Groundwater Transfer Review Summary Form

Transfer/PA # T- 14622

Application: T-14622

Applicant Name: Double J Farms

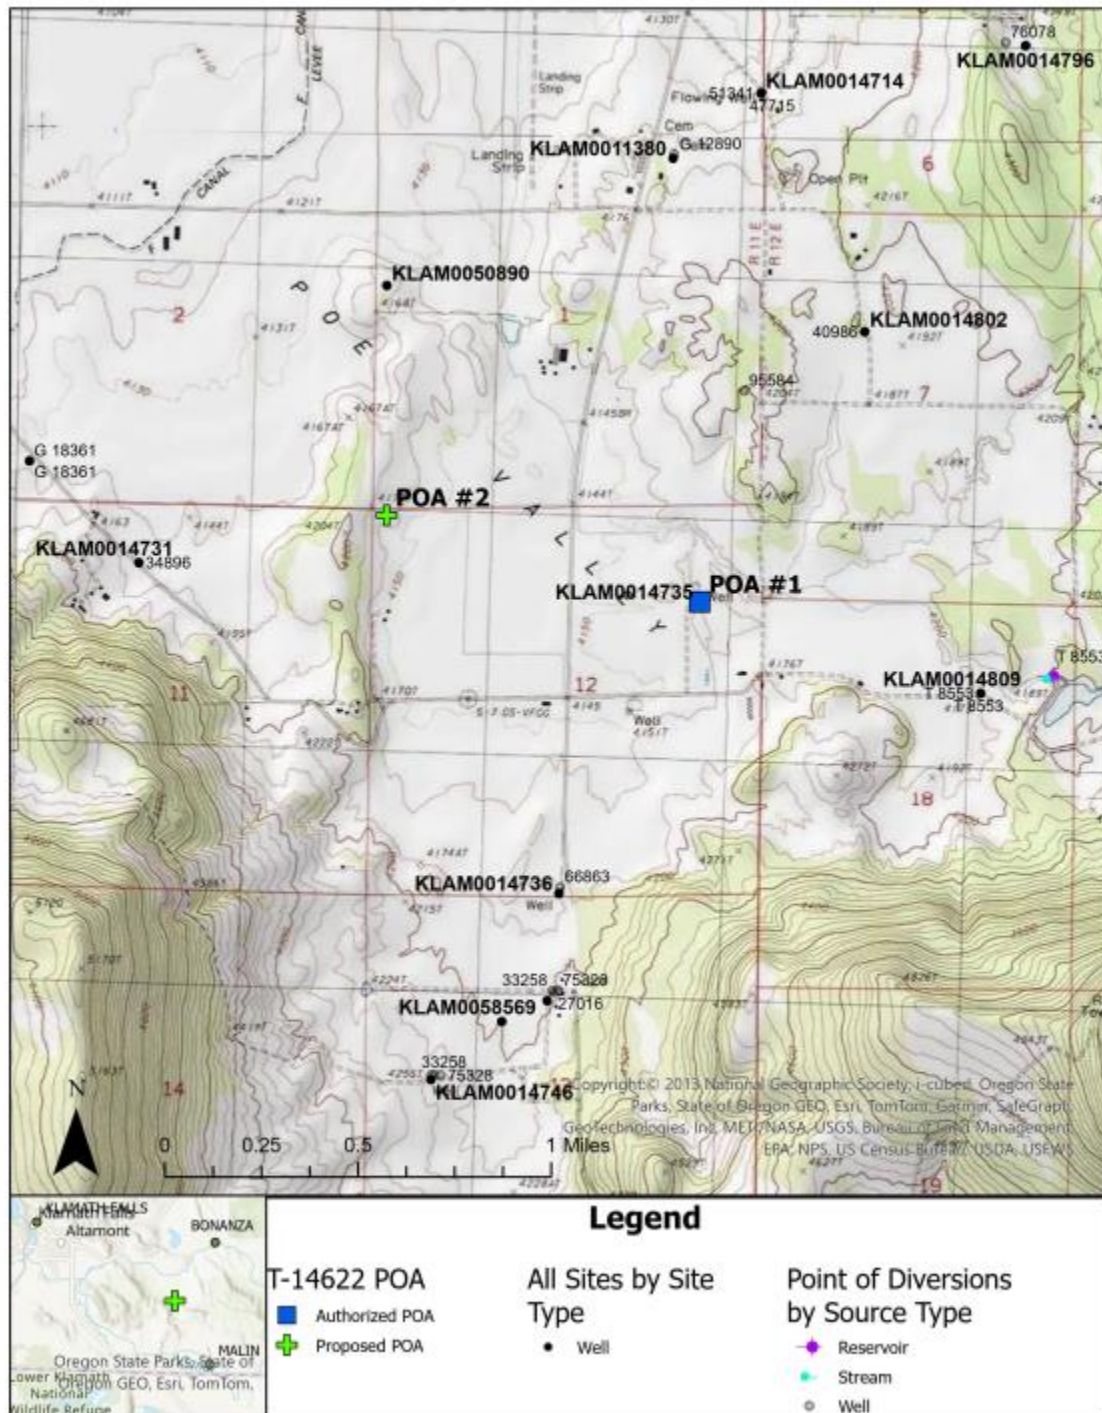
It should be noted that the depth to regional volcanics at the proposed location for POA #2 may be considerably deeper than encountered in authorized POA #1 due to significant fault structure in the area. Of the three well reports filed with the Department in R40S T11E S12 Q-NW, only one (KLAM 59667) appears to encounter volcanics at a depth of 542 feet below ground surface. Well report KLAM 14734 does not appear to encounter volcanics though its total depth of 420 feet below land surface. It is unclear if volcanics were encountered between the depths of 435 and 465 feet below land surface in KLAM 14740.

8. What conditions or other changes in the application are necessary to address any potential issues identified above: The final construction of proposed POA #2 must meet minimal well construction standards and should be cased and sealed into the volcanic units at depth.
